NFPA[®] 70[®]

National Electrical Code[®]

2020 Edition

Reference: Table 430.252 **TIA 20-7** (*SC 19-8-26 / TIA Log #1462*)

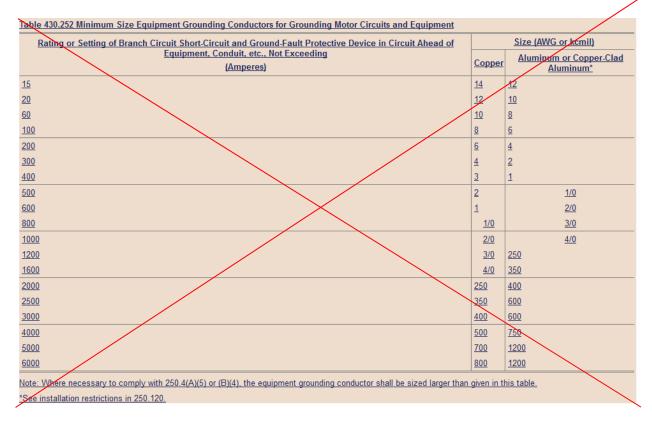
1. Delete Table 430.252 in its entirety:
